Subject: Response to the Staff's Questions Regarding the Root Cause Evaluation for  
Steam Generator Tube Rupture Event of February 15, 2000 (TAC No.  
MA8219)

**Response to Root Cause Evaluation Issues Nos. 2, 6, 14 and 16**

**Consolidated Edison Company of New York, Inc.  
Indian Point Unit No. 2  
Docket No. 50-247  
June 2000**

**Figure 6**  
**SG4, U-bend, Tube R2C5, Crack 1 - 1997**  
**NDE Depth vs. Axial Length**

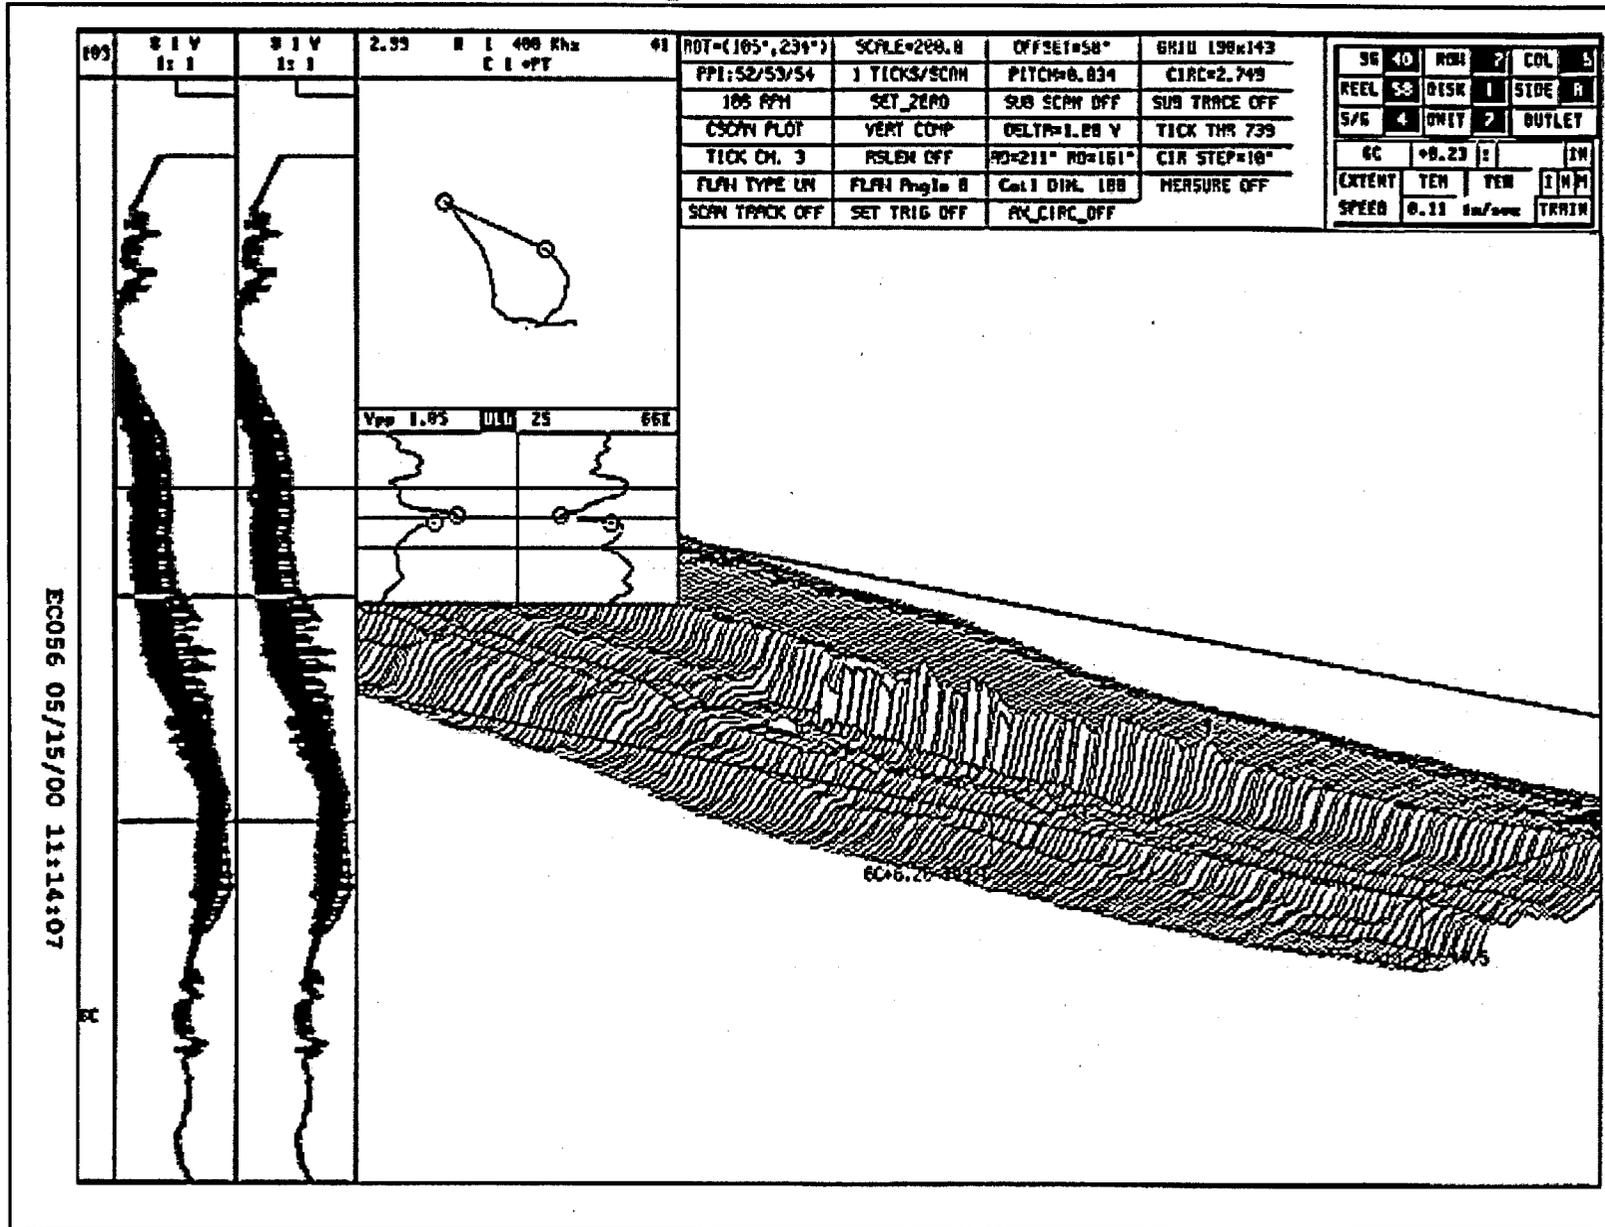
*Section 2 states that inability to detect the precursor indication in R2C5 due to noise was the principle cause of the leakage event and that the growth rate of the indication between 1997 and 2000 was moderate and not a principle cause. Given the low voltage response of the 1997 signal and the high signal to noise, what level of accuracy can be assumed for the depth of the 1997 indication? On what basis?*

The signal to noise (S/N) ratio varies along the length of the observed indication since both the crack and noise signals vary in amplitude and phase along the crack. For example, the amplitude of the crack signal drops off near the end of the crack leading to a low S/N ratio for any noise level at that point. The estimate for S/N therefore implies the maximum value of S/N for the crack indication. To support sizing of the indications, it is necessary to identify and separate the flaw part of the phase response from the noise response. Figure 1 shows the R2C5 noise signal of about 1 volt at a distance away from the observed crack. Figure 2 shows the maximum flaw plus noise signal to be about 2.5 volt which gives a signal to noise ratio of about 1.5. The portion of the total signal undistorted by the noise, representing the crack signal, is about 1.4 volt as shown in Figure 3 giving an alternate S/N about 1.4 at this location. The phase response of this crack signal must be used to size the indication and not the total peak to peak phase response. Figure 4 shows the overall crack plus noise signal at another location to be about 1.5 volt, where the estimate for the undistorted portion of the total signal is about 1 volt. At this location the noise level is about 0.5 volt and leads to a S/N of about 2.
